## **AMENDMENTS TO THE DRAWINGS**

### **REMARKS**

### **DRAWINGS**

Figure 12C

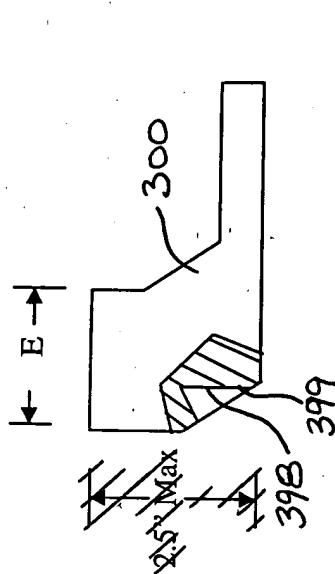
The Examiner noted the amendment filed June 30, 2003 indicated that corrected drawings were attached, but the submittal contained only formal drawings and not corrected drawings. Applicant is herein resubmitting the sheets provided with the amendment filed 6-30-03, with the following clarifications. The sheets provided herein are labeled "Replacement Sheets". Replacement Sheets 1/9 to 6/9, 8/9 and 9/9 are formal drawings showing Figures 1-11 and 13-14, respectively, which Applicants respectfully request be substituted for the originally filed sheets 1/9 to 6/9, 8/9 and 9/9, respectively. Sheet 7/9 includes figures 12A, 12B and 12C. Figures 12A, 12B and 12C have been

converted to formal drawings and specific dimensions have been deleted as follows. In figure 12A, the dimensions --3.0"-- and --2.0"-- and the dimension reference lines for these dimensions have been deleted. In figure 12B, the dimensions --4.0"-- and --3.0" MAX-- and the dimension reference lines for these dimensions have been deleted. In figure 12C, the dimension --2.5" MAX"-- and the dimension reference line for this dimension have been deleted. An Annotated Sheet 7/9 is provided for information and has been marked in red to show deletions made to the originally filed Sheet 7/9.
